PRODUCT INFORMATION NOTICE

Subject: SLOPED DRAIN PAN HEAVY-DUTY AND WAREHOUSE EVAPORATORS

PIN #: TCO-50
Date: 08-29-2023

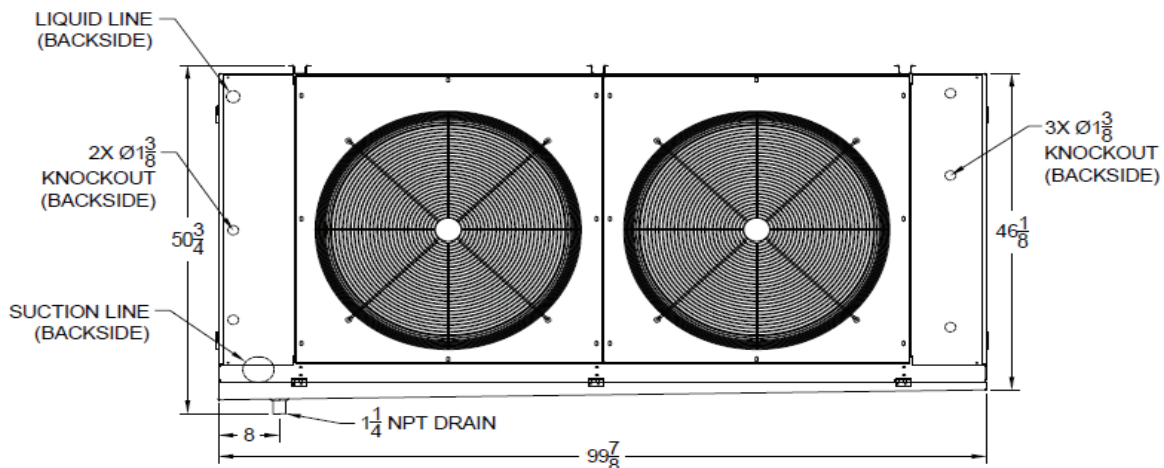
Due to continuous product development and customer feedback the heavy-duty and warehouse evaporators have been redesigned to include a sloped drain pan and air dam, and the sloped hanging brackets will no longer be used.

Note: Overall unit height increases approximately 2" on the drain connection end.

All orders submitted and entered before 09/18/2023 will be manufactured using the sloped hanging brackets and all orders submitted on or after 09/18/2023 will be manufactured using the sloped drain pan, air dam and level hanging brackets.
